# ***FALCON SERVICE BULLETIN***

## **FALCON 7X**

**No 056-R1**

**STANDARD PRACTICES  
AIRFRAME WIRING  
PROTECTION IMPROVEMENT OF VARIOUS WIRING  
ASSEMBLIES**

**Figure 9: SECTION 7X-056-4 (M937, POINT 2)**

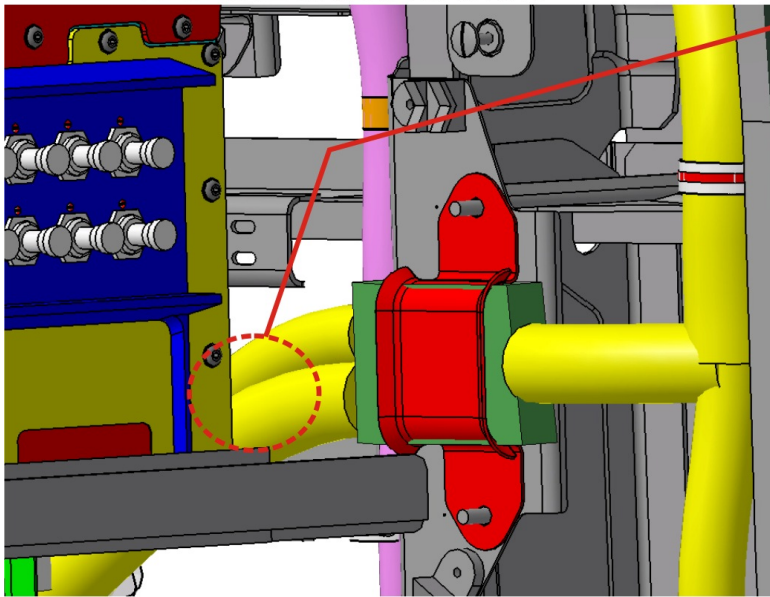
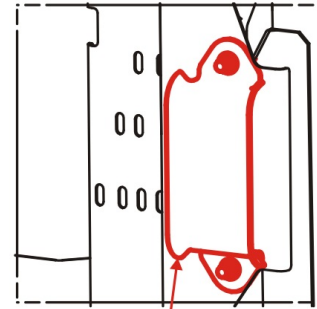
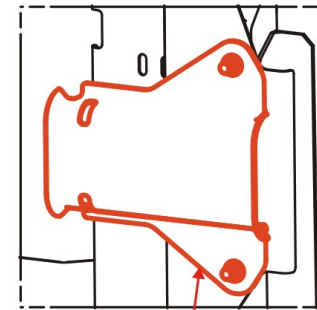
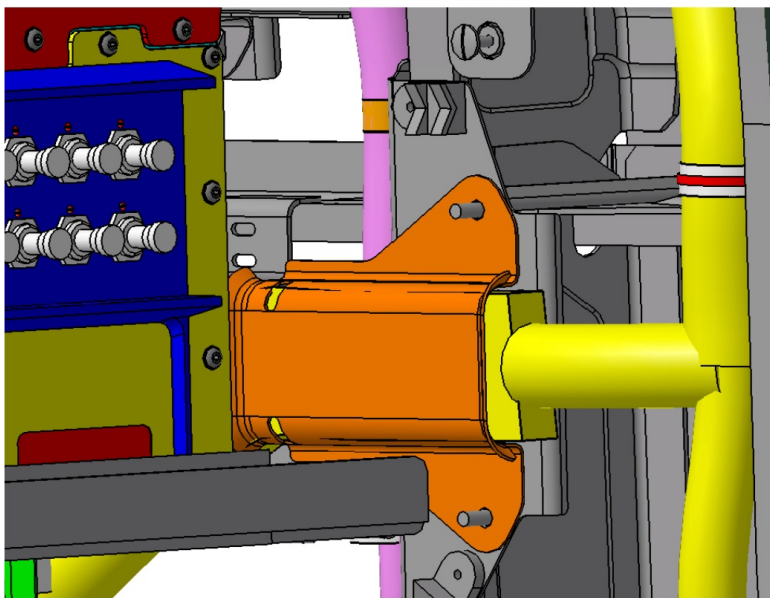
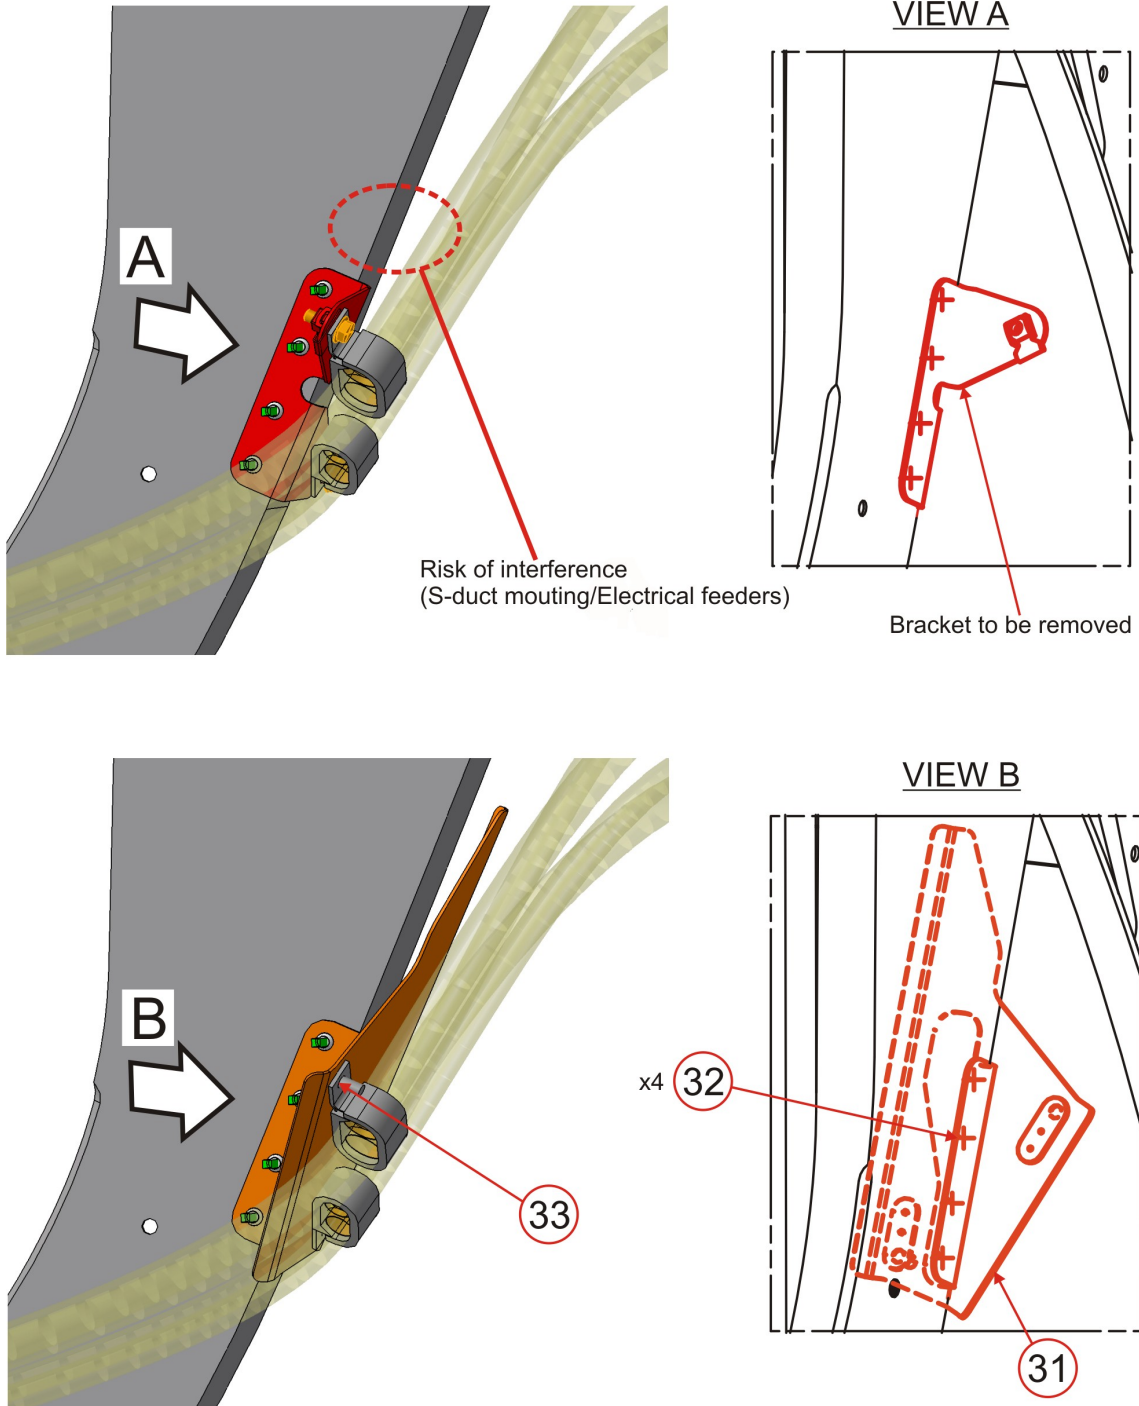
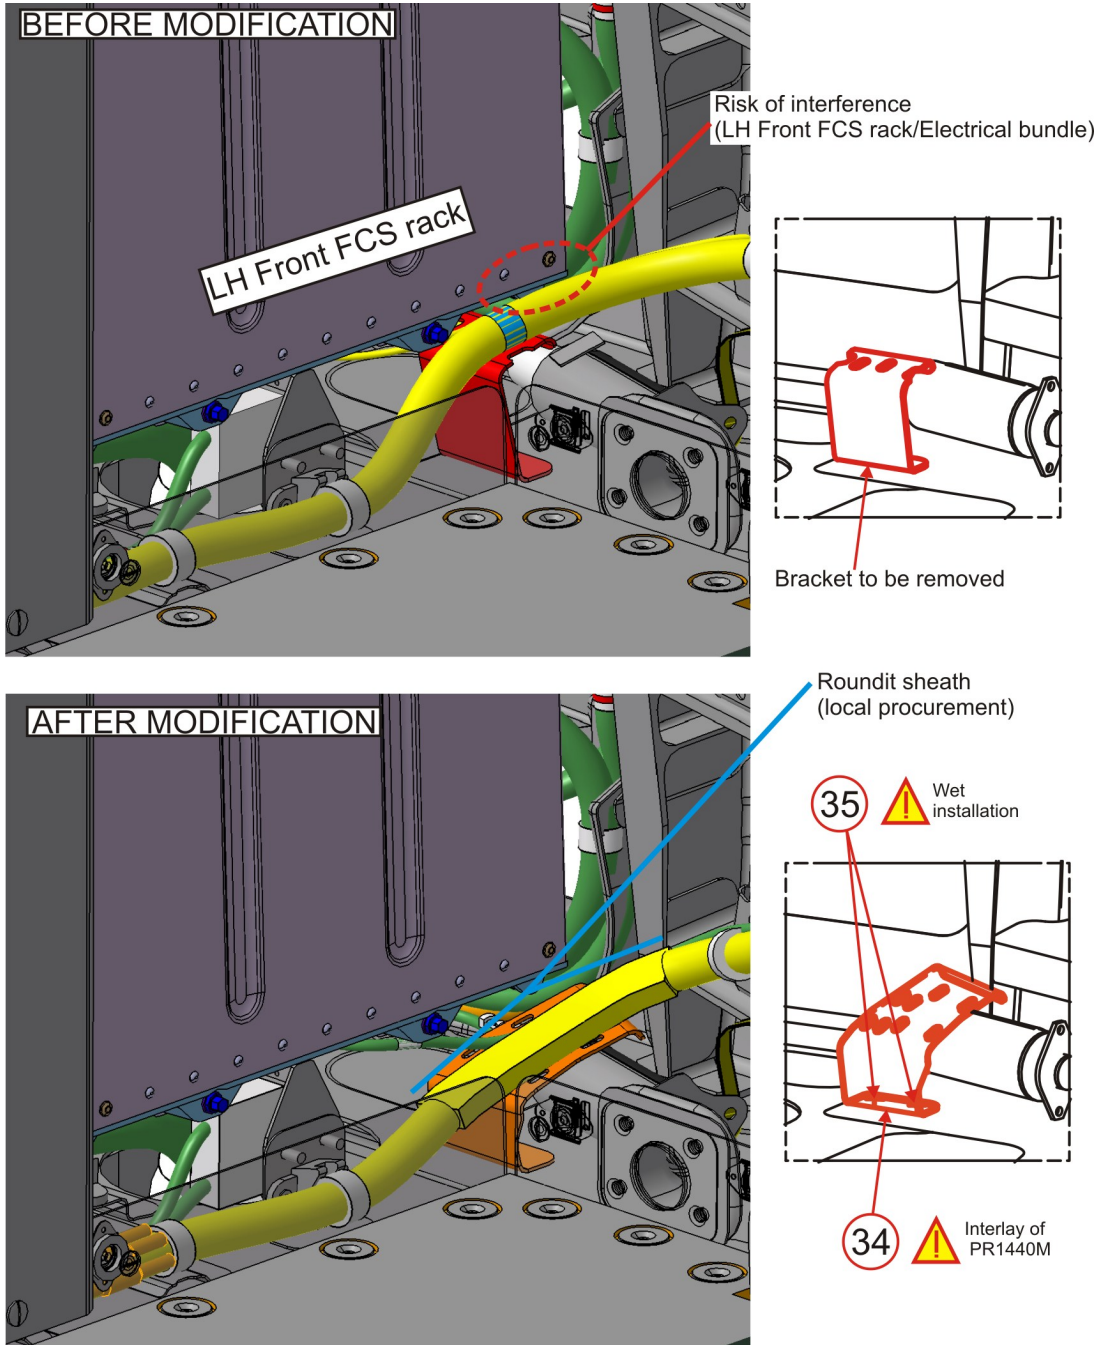
- (a) Remove the LH rear SPDB ([L2000PM](#)) (Refer to [TASK 24-62-09-900-801](#)).
- (b) Replace the existing protector with a new one (30-fig. 9)
- (c) Install the LH rear SPDB ([L2000PM](#)) (Refer to [TASK 24-62-09-900-801](#)).

Risk of interference  
(LH Rear SPDB/Electrical bundle)

Protector to be removed

**Figure 10: SECTION 7X-056-4 (M937, POINT 3)**

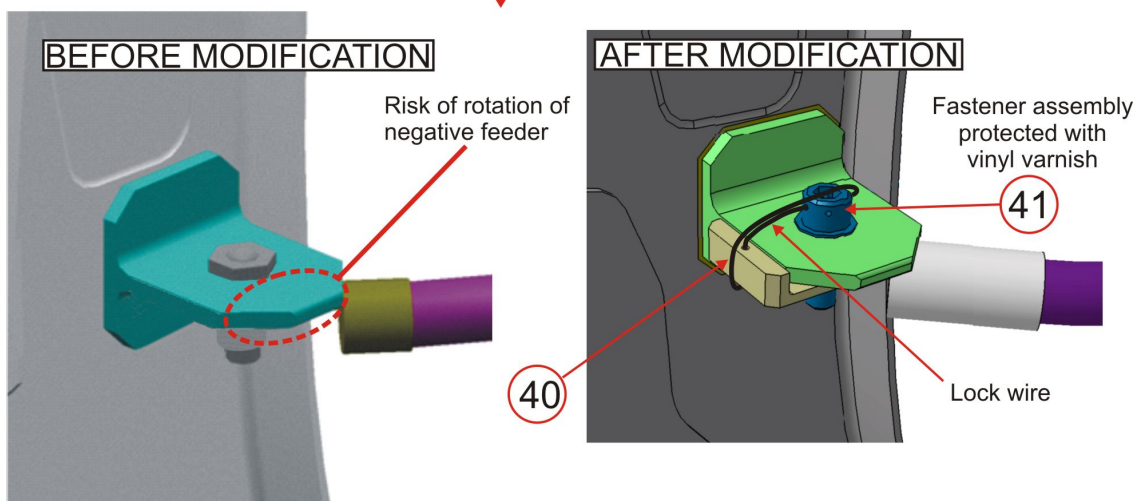
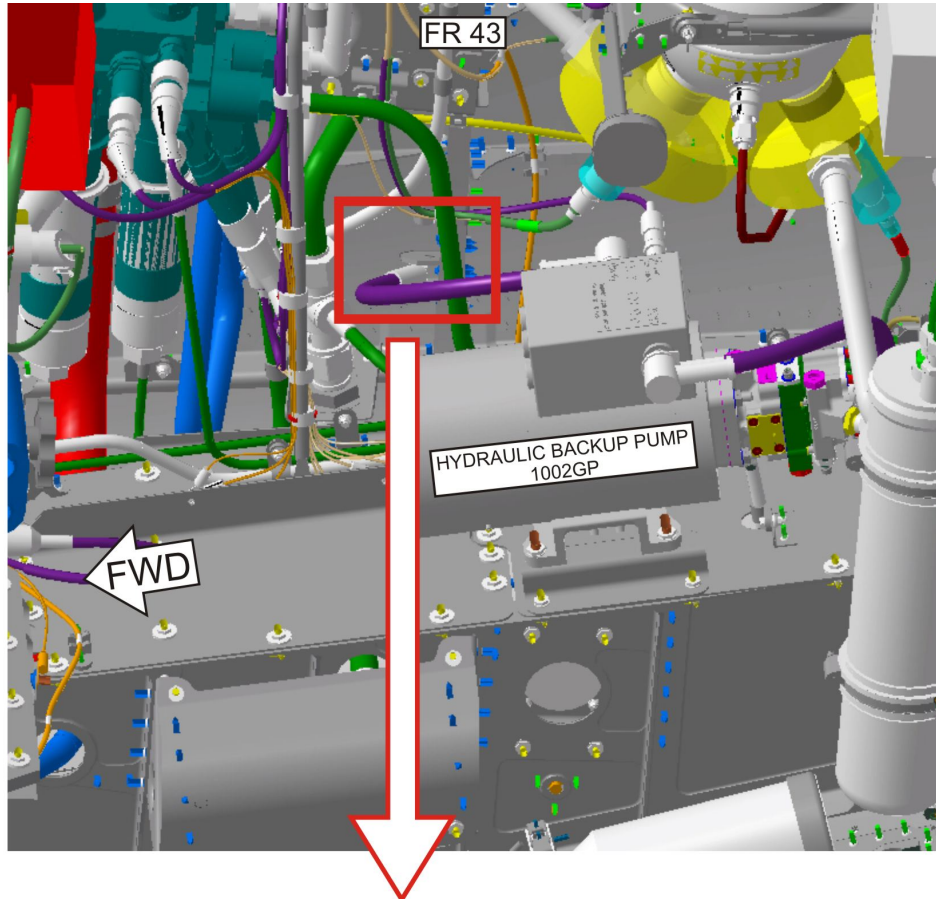
- (a) Remove the LH rear SPDB ([L2000PM](#)) (Refer to [TASK 24-62-09-900-801](#)).
- (b) Unclamp the four electrical feeders.
- (c) Remove the existing bracket from the FR40.
- (d) Counterdrill the new bracket (31-fig. 10) according to the FR40 holes.
- (e) Install the the new bracket (31-fig. 10) on the FR40, using four rivets (32-fig. 10).
- (f) Secure the four electrical feeders on the new bracket, using existing attaching parts and new nut (33-fig. 10).
- (g) Install the LH rear SPDB ([L2000PM](#)) (Refer to [TASK 24-62-09-900-801](#)).

**Figure 11: SECTION 7X-056-4 (M937, POINT 4)**

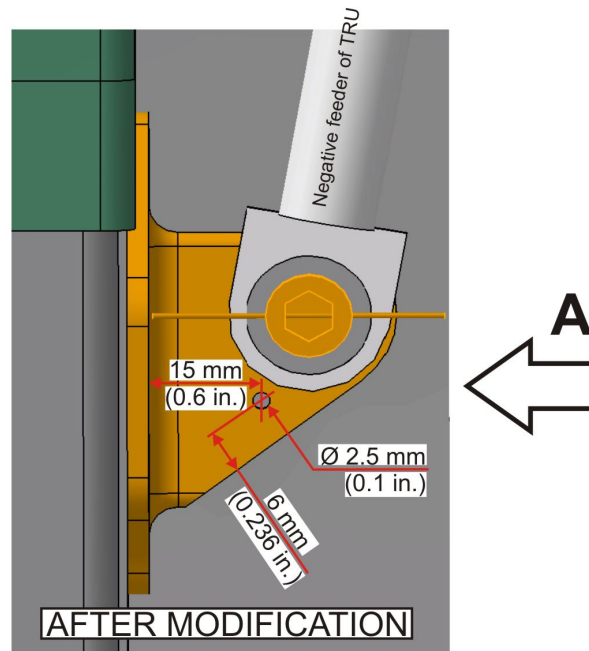
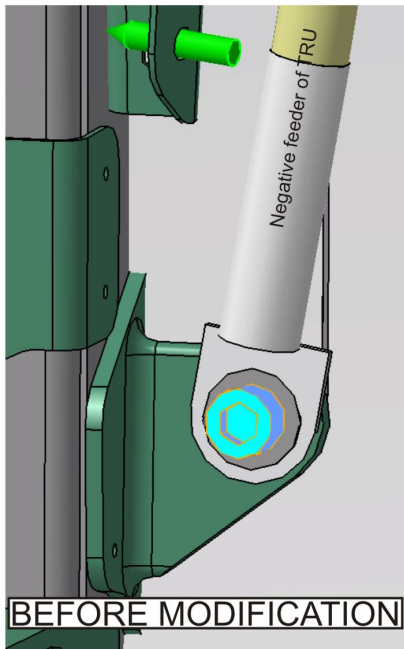
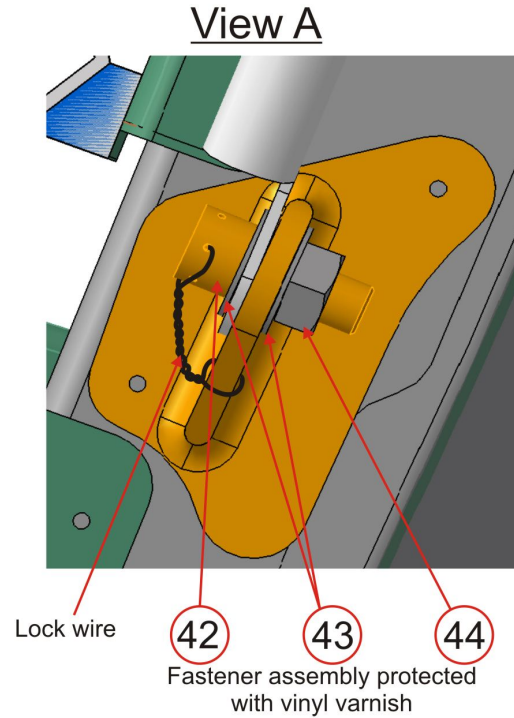
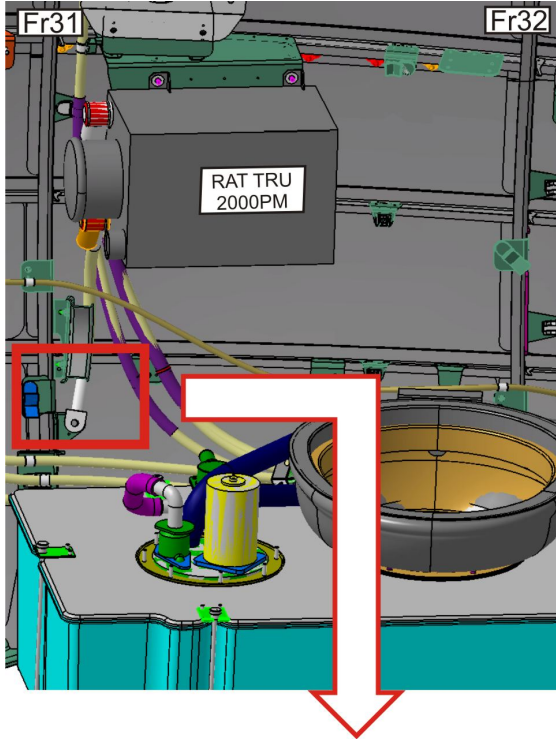
- (e) Install the new bracket (34-fig. 11) with [interlaying sealant](#), using rivets (35-fig. 11) with [interlaying sealant](#) under the rivet head (Refer to [TASK 20-32-00-390-801](#)).

(f) Position [ROUNDIT](#) type sheath as indicated on [fig. 11](#) and maintain it in position using white bindings.

**Figure 12: SECTION 7X-056-5 (M954, POINT 1)**

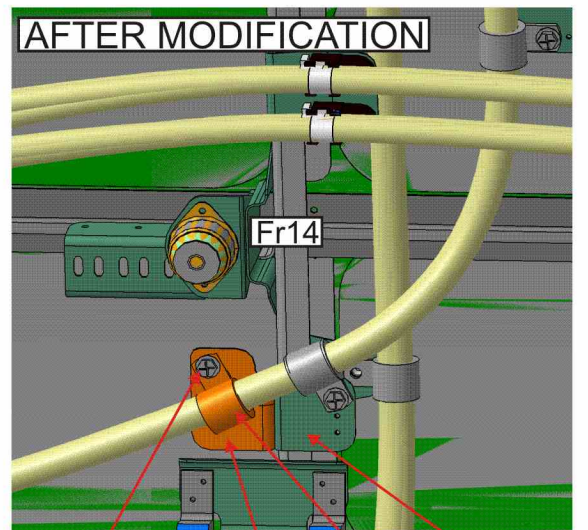
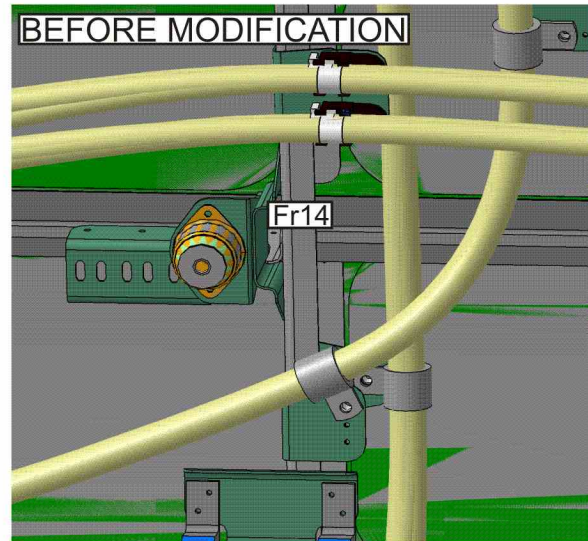
- (a) Locate the negative electrical power lead connection of the hydraulic backup pump (**1002GP**).
- (b) Unscrew the negative electrical power lead from the aircraft structural ground.
- (c) Connect the negative electrical power lead with new locking plate (40-fig. 12) and new screw (41-fig. 12), torque value: 41 in.lbf ± 4 in.lbf (0.45 m.daN ± 0.04 m.daN).
- (d) Secure the screw with lock wire.
- (e) Apply **vinyl varnish** on the fastener assembly.

**Figure 13: SECTION 7X-056-5 (M954, POINT 2)**

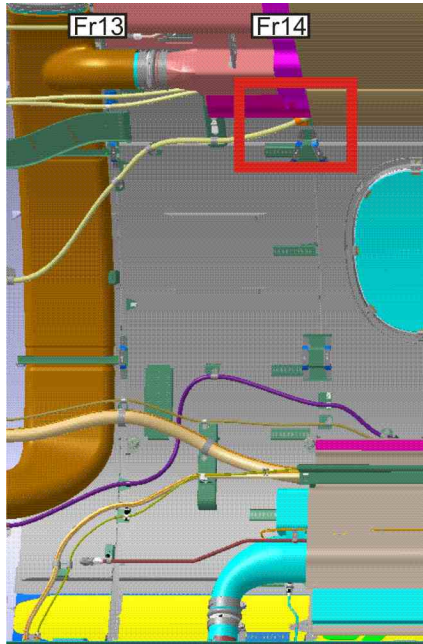
- (a) Remove the interior accommodation in order to gain access to the negative DC power lead connection of the RAT TRU (**2000PN**).
- (b) Unscrew the negative DC power lead from the aircraft structural ground.
- (c) Drill the ground support to a dia. 2.5 mm (0.01 in.).
- (d) Connect the negative DC power lead to the structural ground using new attaching parts (42, 43 and 44-fig. 13), torque value: 77.88 in.lbf ± 7.7 in.lbf (0.88 m.daN ± 0.08 m.daN).
- (e) Apply **vinyl varnish** on fastener assembly.
- (f) Secure the screw with lock wire.

**Figure 14: SECTION 7X-056-5 (M954, POINT 3)**

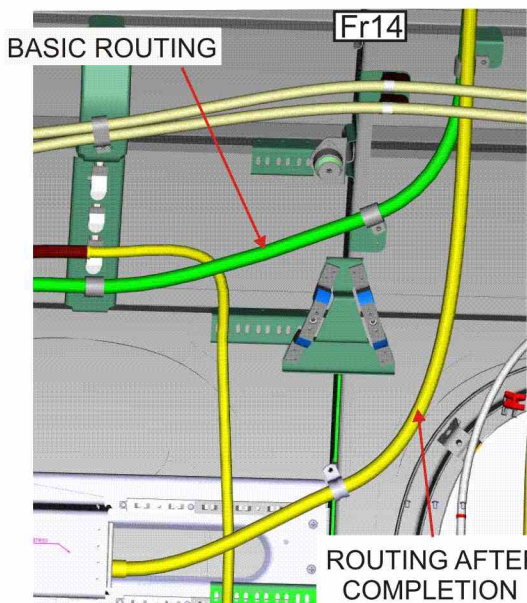
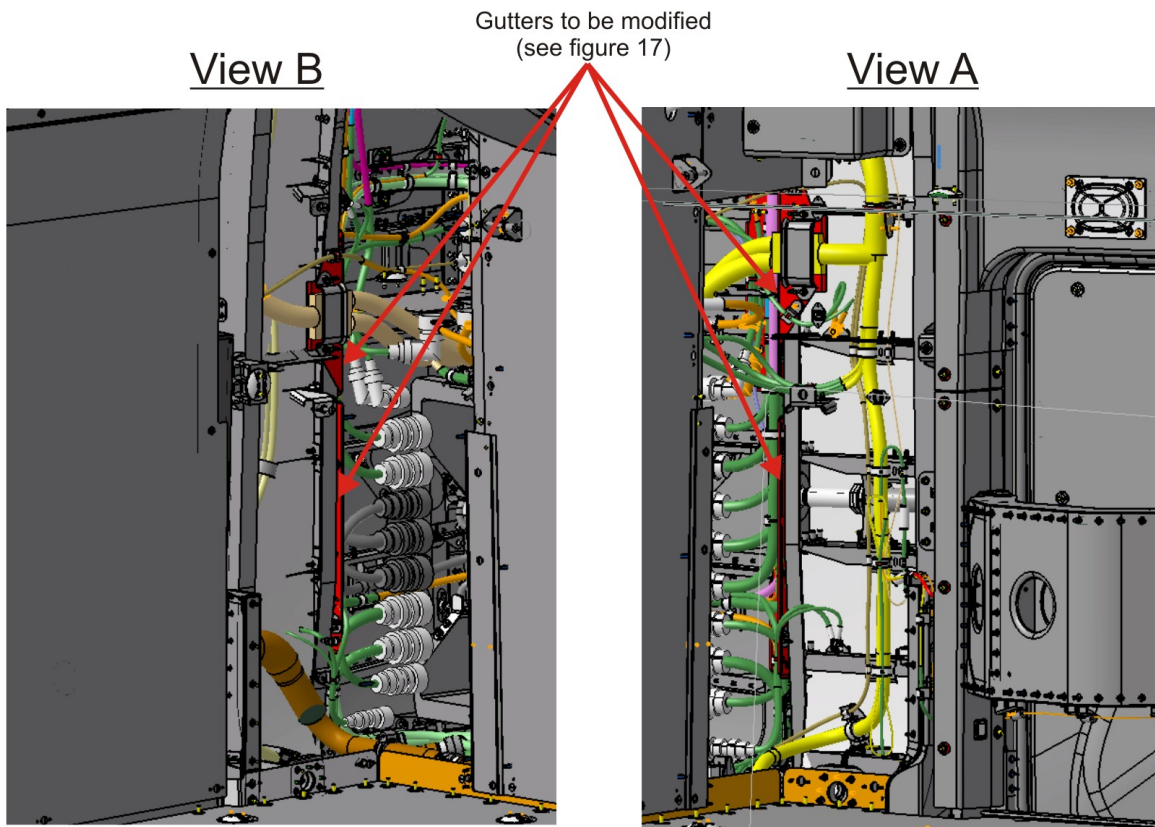
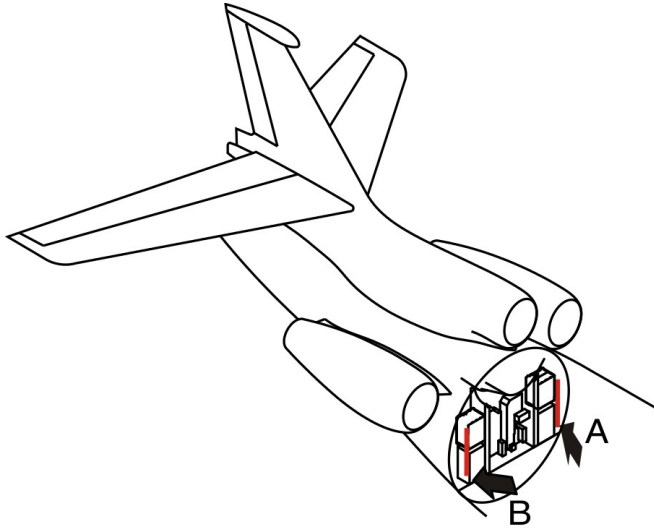
- (a) Remove the interior accommodation (RH main galley/Crew rest/partition/valance panel) in order to gain access to the routing of electrical feeders at FR14.
- (b) Unclamp, protect and move the electrical feeders away from the modification area (bracket (A-fig. 14)).
- (c) Remove the two rivets from the bracket (A-fig. 14).
- (d) Counterdrill the new bracket (45-fig. 14) according to the FR14 existing holes.
- (e) Install the new bracket (45-fig. 14), using rivets (46-fig. 14).
- (f) Secure the electrical feeders with existing clamps and new clamp (47-fig. 14), using attaching parts (48 and 49-fig. 14).
- (g) Restore the interior accommodation.

Replace existing rivets of bracket (item A)
